Infrastructure NSW's Blackwattle Bay Response to Submissions

I write to you regarding Infrastructure NSW's (INSW) Blackwattle Bay Response to Submissions (RtS) currently open for comment.

To assist the project, the City completed a [Design Review](#) of the proposal which found the Blackwattle Bay proposal needed the following improvements:

Figure 9 Foreshore width – INSW study June 2021

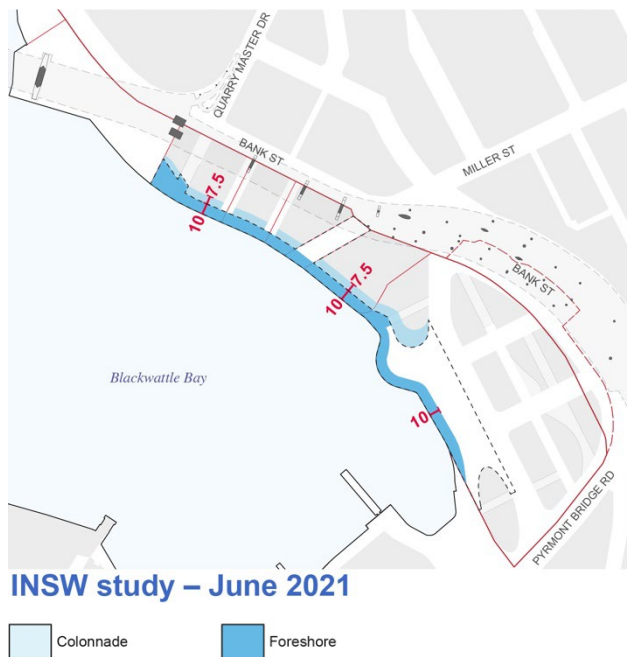
As shown in Figure 9, the INSW study proposed a promenade of 10 metres:

Figure 10 Foreshore width – CoS Design review April 2022

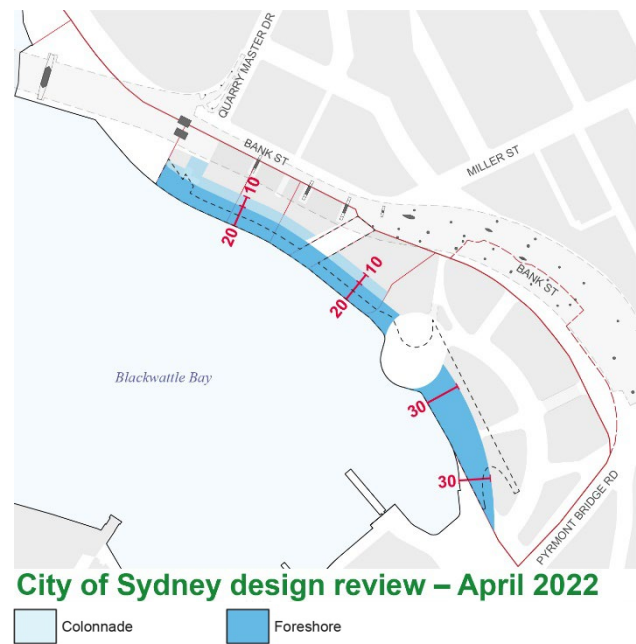
The Design review agreed with the Pymont Peninsula Place Strategy. The Design review recommends a foreshore reserve of 30 metres (refer Figure 10), comprising:

- 10 metres for dwelling;
- 10 metres for movement; and,
- 10 metres for outdoor dining, within a colonnade in the north west where the site is not as deep as in the south where the full 30 metres is unimpeded.

Figure 16 Solar insolation of southern foreshore (Winter Solstice)

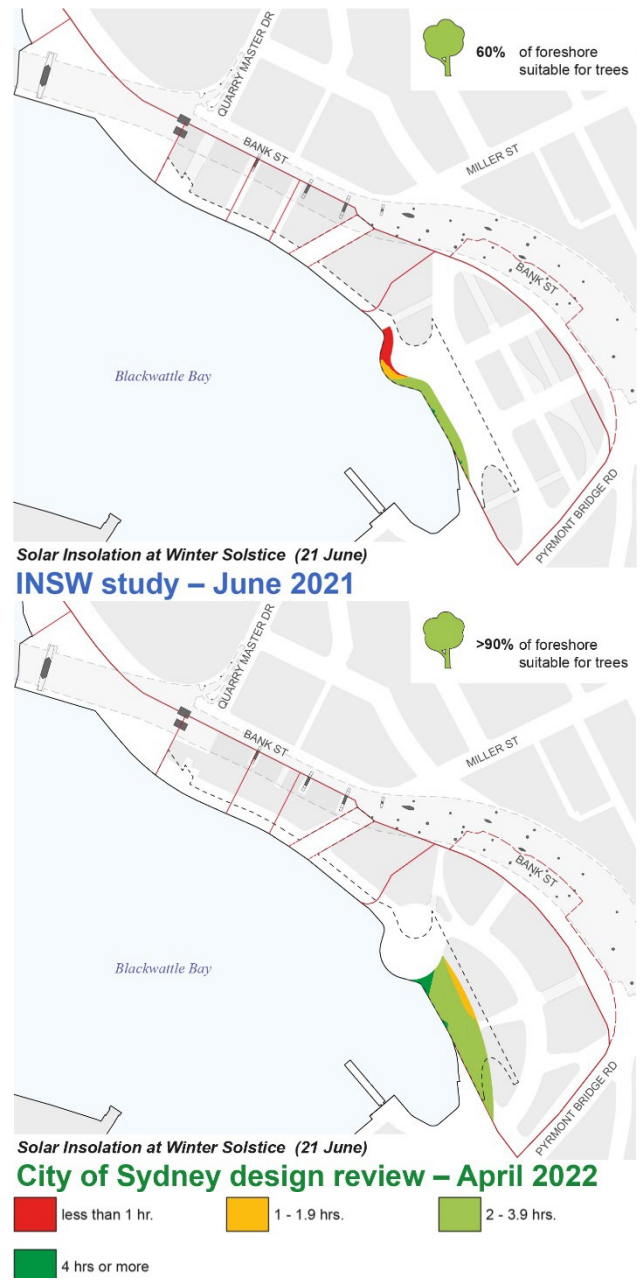
The southern foreshore promenade faces west-south-west. Public spaces with this aspect can be provided with sufficient winter sunlight if building forms allow a minimum two hours of continuous sunlight (between 9:00 am-3:00 pm at the winter solstice). The minimum of two hours of sunshine will support healthy growth for most tree species, see Figure 16.

Figure 17 Solar insolation of park (Winter Solstice)

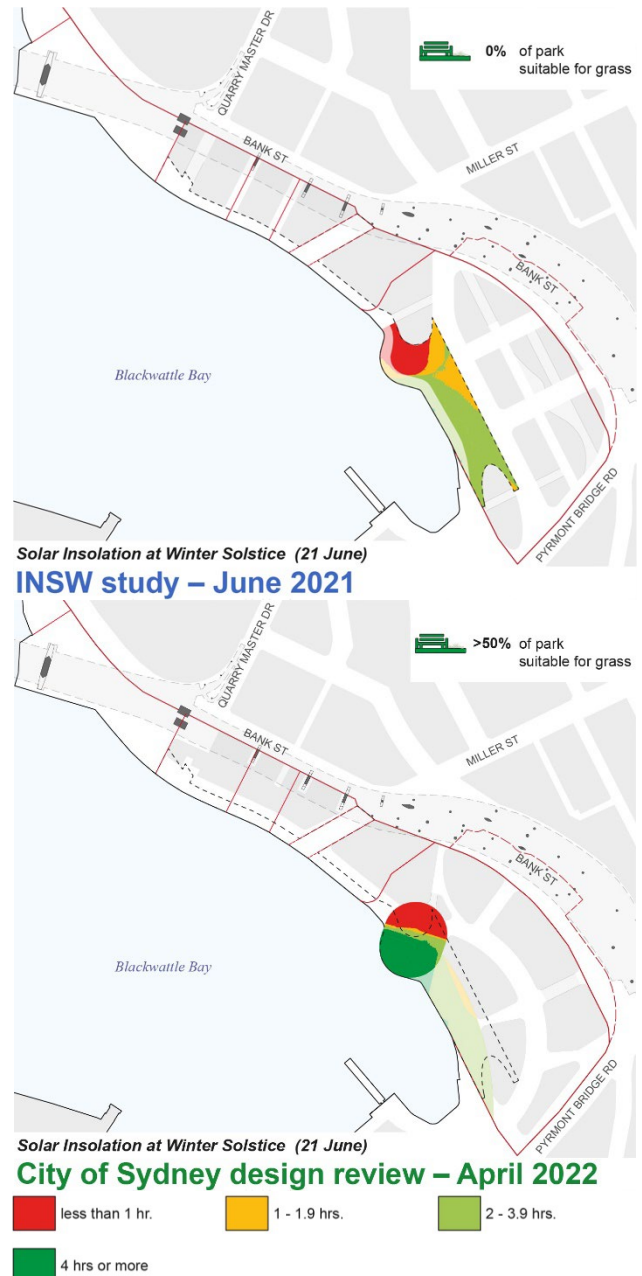
The INSW study park will not be green. For a park to sustain grass with intensive use and for people's amenity; four hours of sunshine at the winter solstice (21 June) is required. The City's Development Control Plan requires this amount of sunshine for 50% of the area of the park (Sydney DCP 2012, Section 3.1.5, Provision (3)(a)). The INSW study park has no area with four hours sunshine, refer Figure 17. The design review locates the park on the promontory, with a northerly major axis, where sun access is more easily gained with less effect on building form and adjusts the building form to its north to ensure 50% of its area receives four hours sunlight.

Figure 19 Wind tunnel results of the wind tunnel study undertaken by Windtech for INSW (Appendix I, pp.23, Figure 6)

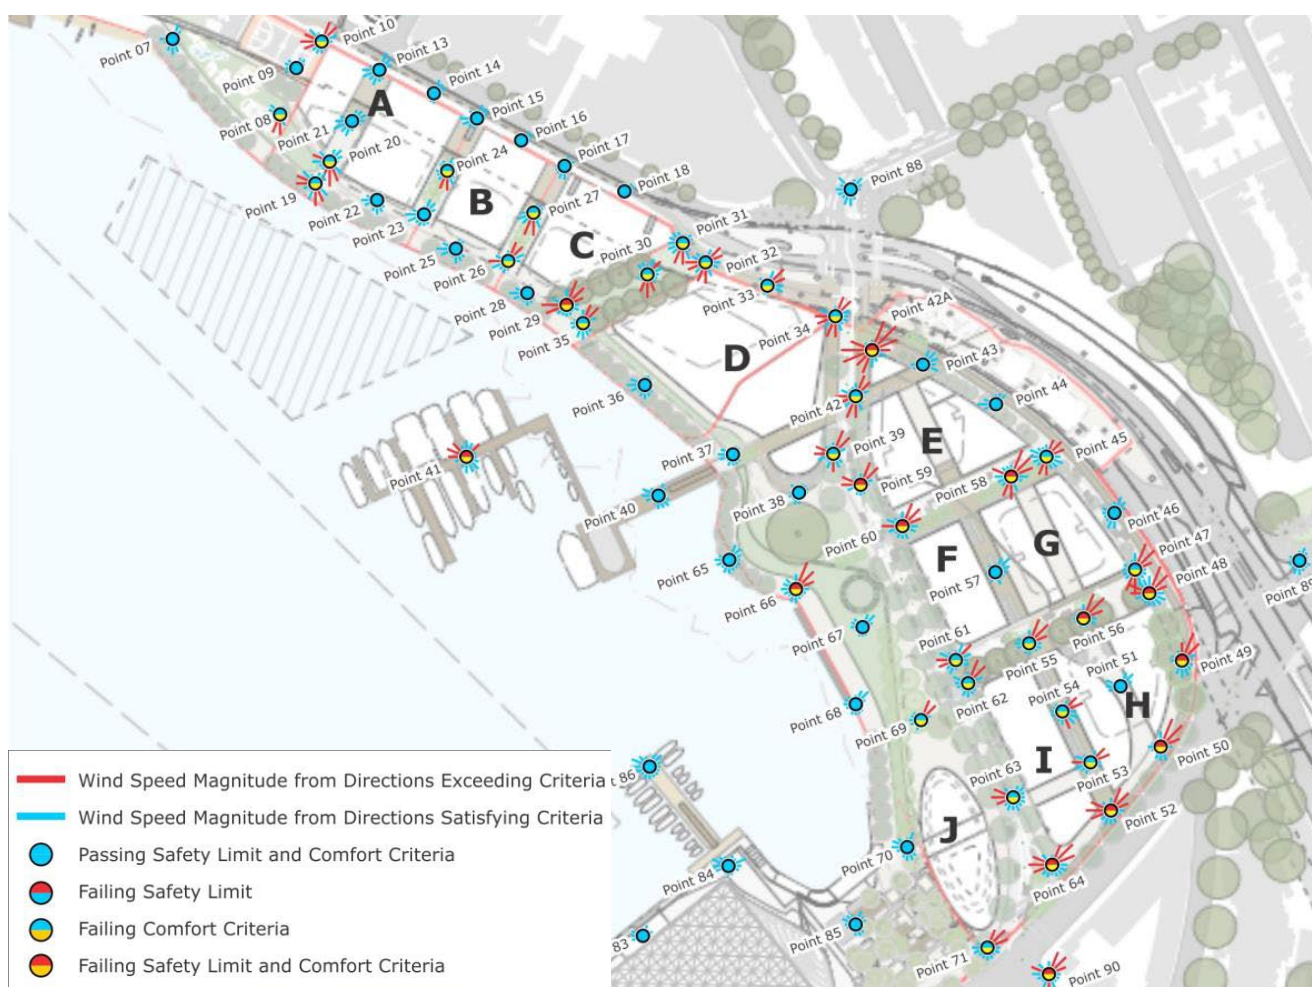
The area is exposed to winds with relatively low built form through Pyrmont to the east / north east and an open and unprotected frontage to Blackwattle Bay to the west / southwest (refer Figure 21 and Figure 22 of seasonal temperature wind roses). The wind tunnel study undertaken by Windtech for the INSW study is shown below in Figure 19. Multiple locations experience poor levels of pedestrian comfort and exceed wind safety standards.

The CoS Design review recommends avoiding straight through-streets from the foreshore to Pyrmont by offsetting streets and connections to significantly reduce or avoid the effects of wind channelling, this is shown in figure 20. These and other changes, described later in this report, reduce wind velocity and provide a safe and comfortable pedestrian environment.

Figure 28 Comparison of existing, INSW study and CoS Design review for the Bank Street and Miller Street arrangement

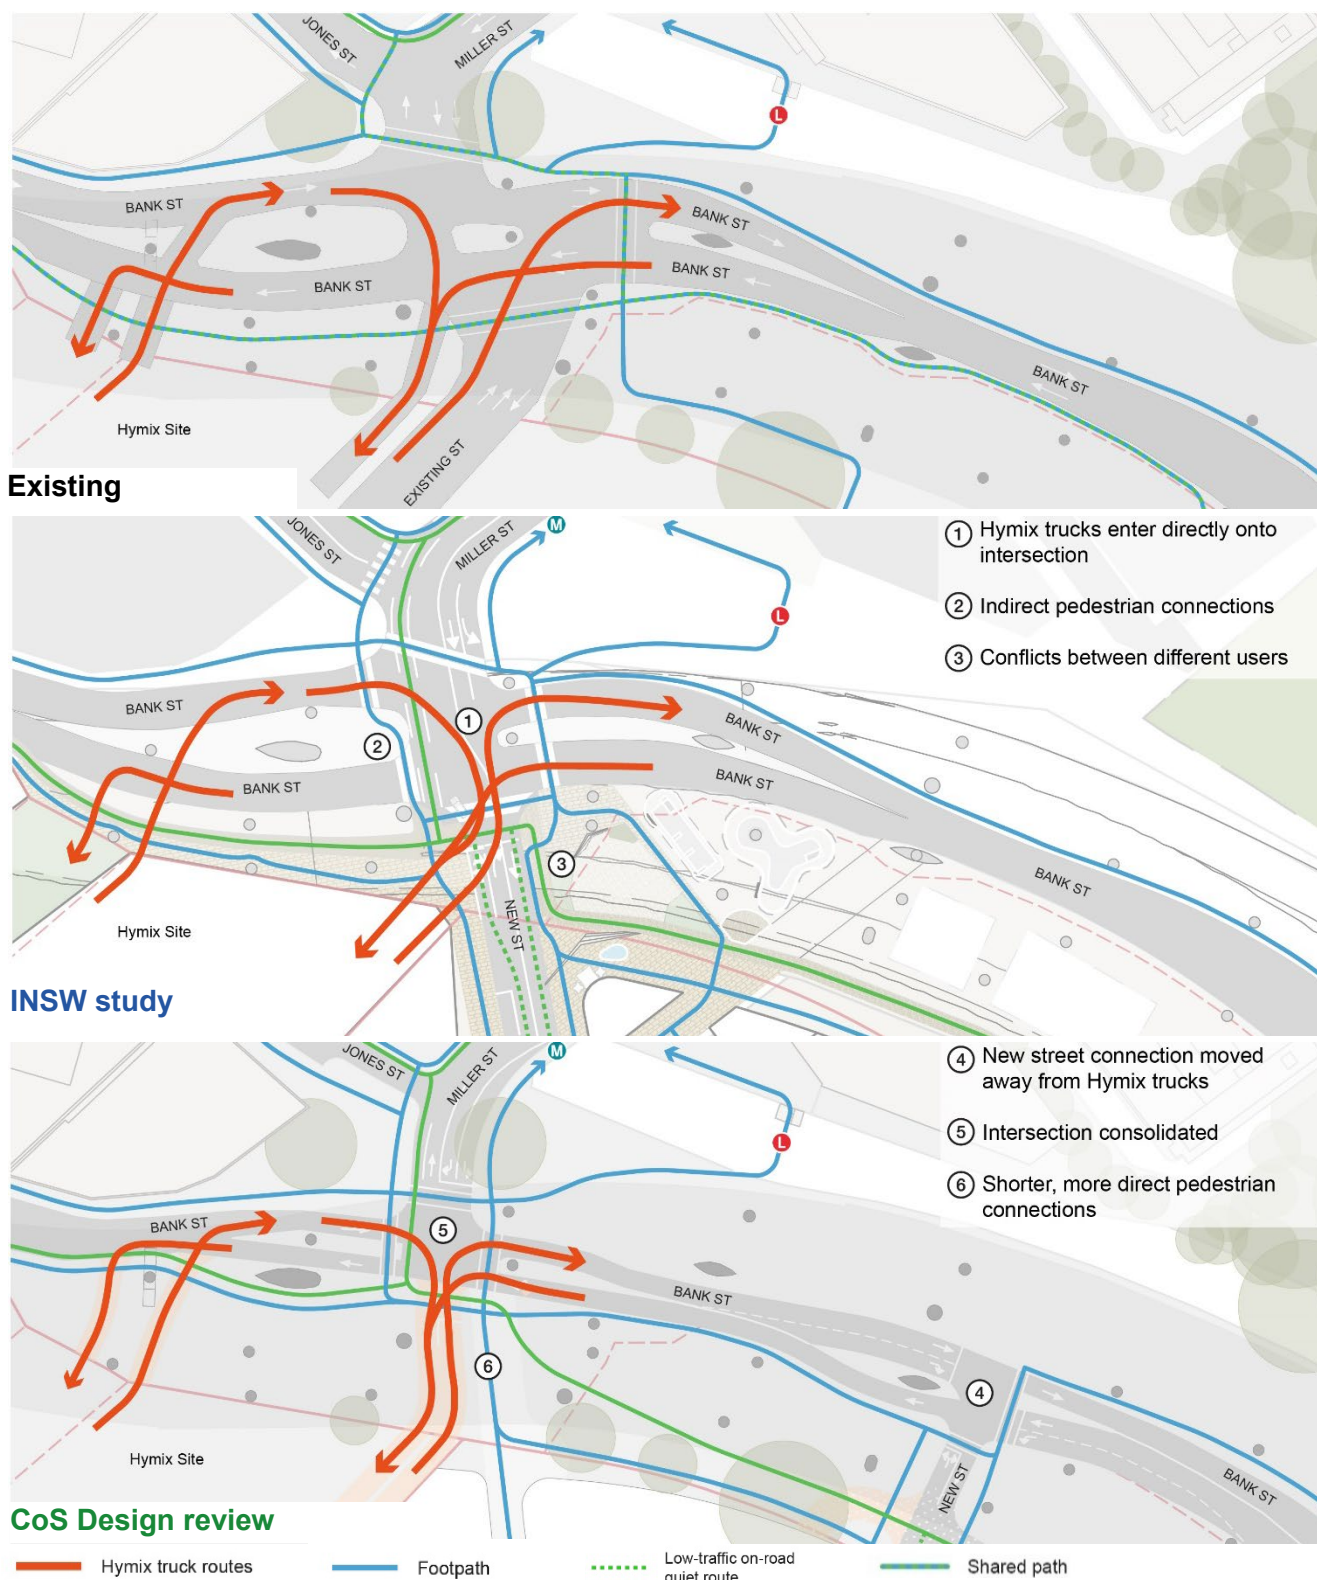
The Miller Street intersection is illustrated in Figure 28 below, and shows that:

- Hymix and the associated concrete trucks and double semi-trailers (shown in Figure 27) are likely to continue operating for the foreseeable future (see section 4.1.8), with the trucks entering and leaving the southern site in a counterflow arrangement;

Figure 29 Comparison of INSW study and CoS Design review for the Wattle Street and Pymont Bridge Road/Bridge Road arrangement

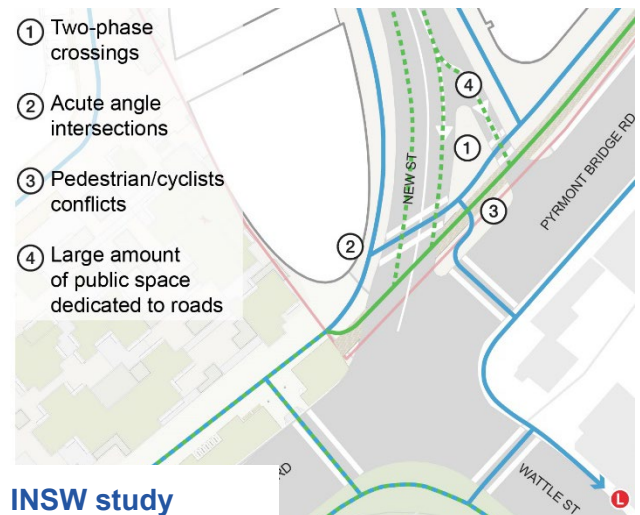
The INSW study proposes a new street connecting at a sharp angle to the existing Wattle Street intersection, necessitating a left-out slip lane, shown at the top of Figure 29.

- Allows a single-phase pedestrian/cyclist crossing for all road crossings;
- Has all turning manoeuvres at safer, 90° angles into the New Street, slowing speeds and improving sight lines;
- Reduces conflicts between pedestrians and cyclists; and,
- Dedicates less public space to roads.

Figure 30 Comparison of INSW study and CoS Design review for the Wattle Street and Pyrmont Bridge Road/ Bridge Road arrangement

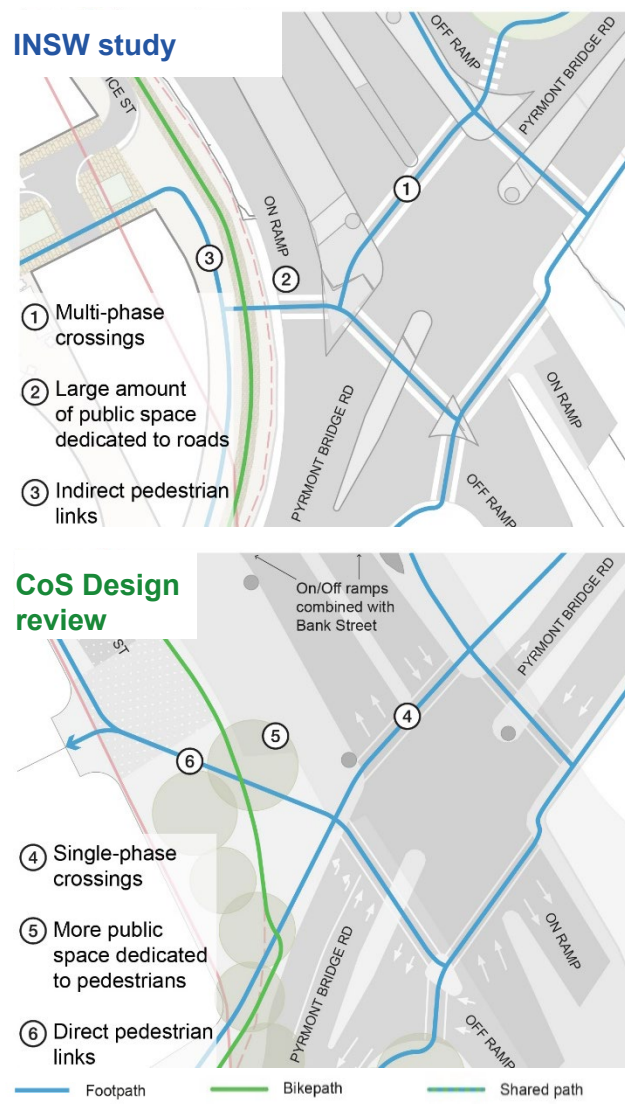
The Pyrmont Bridge Road and Bank Street intersection is a sprawling intersection with multi-phase pedestrian crossings that prioritise space to vehicles. As shown in Figure 30, the NSW study maintains the status quo, while increasing pedestrian demand on the constrained pedestrian routes.

Owing to the complexity a traffic analysis would be required to determine the exact configuration of this intersection.

Figure 31 Tree coverage and types

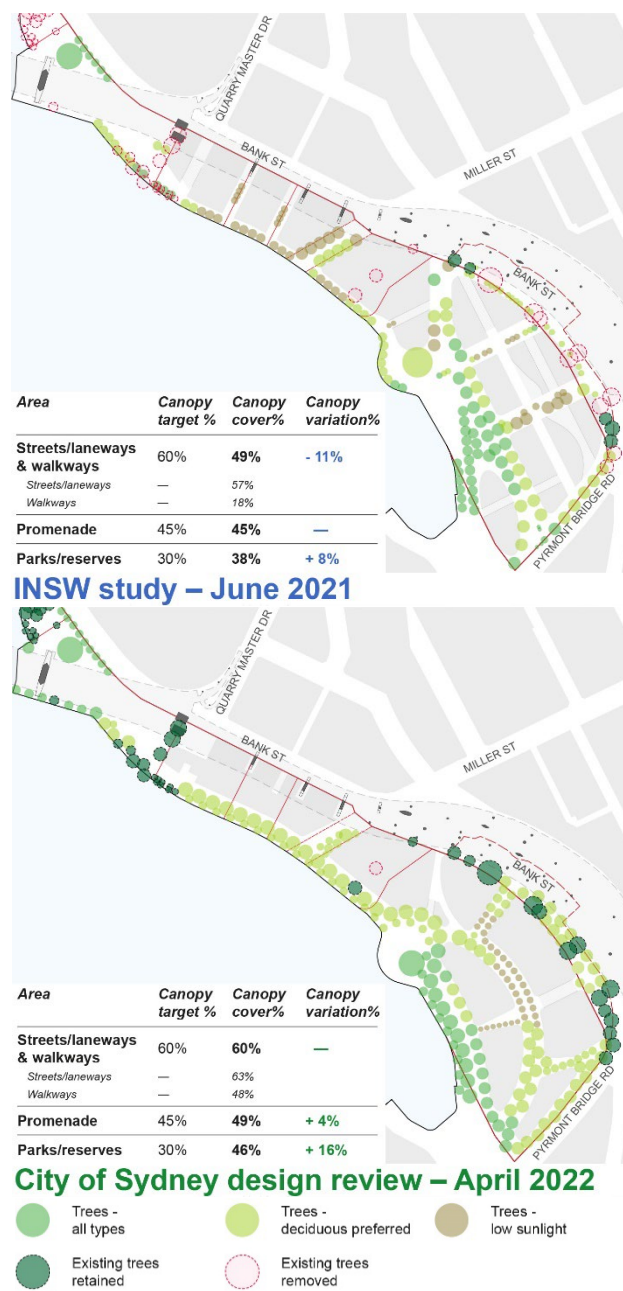
The detailed solar studies within Sections 3.2.3, 3.3.4, and 3.2.5 indicate low levels of sunlight are received within many of INSW study's public spaces. These spaces support only low sunlight tolerant tree species. As shown in Figure 31, a significant amount of the trees depicted within the exhibited plans are in areas of suboptimal sunlight. The INSW study places underground carparking beneath one of the laneways preventing the street from supporting larger trees, reducing canopy coverage below the target set for streets and laneways.

Figure 31 shows the proposed canopy cover of the INSW study and CoS Design review. By focussing on creating a better climate with more sunlight and comfortable, safe wind speeds, the CoS Design review found that tree canopy cover exceeding the targets can be provided throughout the site's public spaces.

Figure 34 Comparison of developable area between the INSW study and CoS Design review

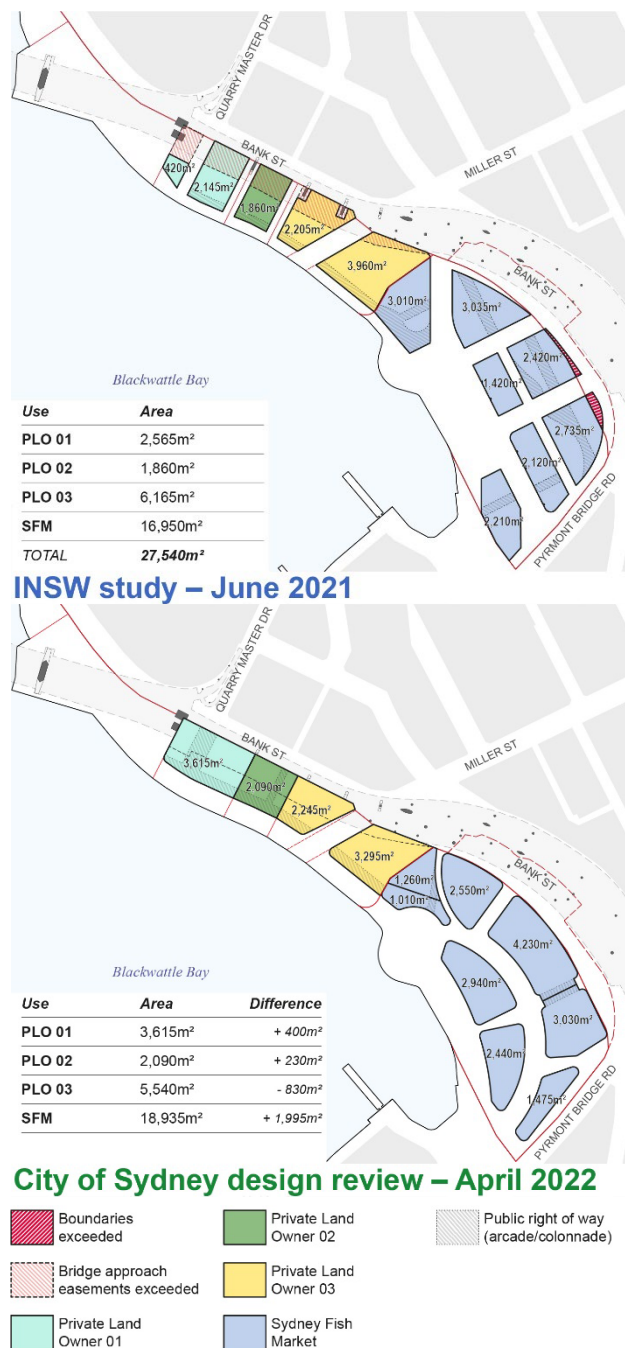
The Design review found that the INSW study reference plan (refer Figure 34) overestimated the development potential by:

The Design review found that the site can be divided to increase the developable area, particularly on the fish market site, and maintain existing site boundaries while providing generous public space. Increasing the developable area lowers the intensity of development and its effects as the same amount of floor area is spread over a larger site area.

Figure 35 Comparison of tower forms between the INSW study and CoS Design review

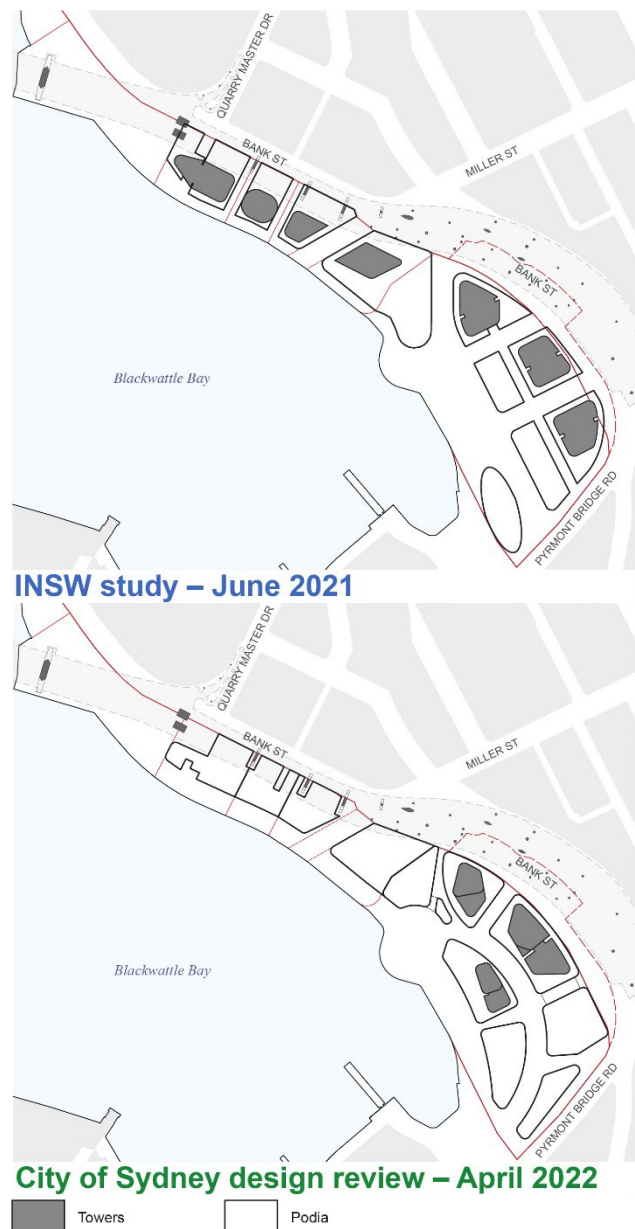
The INSW study proposes seven towers, the tallest exceeding the current tallest building (Sofitel Darling Harbour) on the Pyrmont peninsula by 23 metres. The number of towers shown at the top of Figure 35 creates several issues, including:

- consolidates towers in the widest part of the study area, minimising impacts on surrounding areas;
- diminishes height to the south, minimising overshadowing impacts;
- removes towers from along the foreshore promenade reducing visual, wind and solar impacts on the waterfront; and,
- reduces the overall maximum height from RL 156 metres to RL 120 metres, the same height as the Anzac Bridge south pylon.
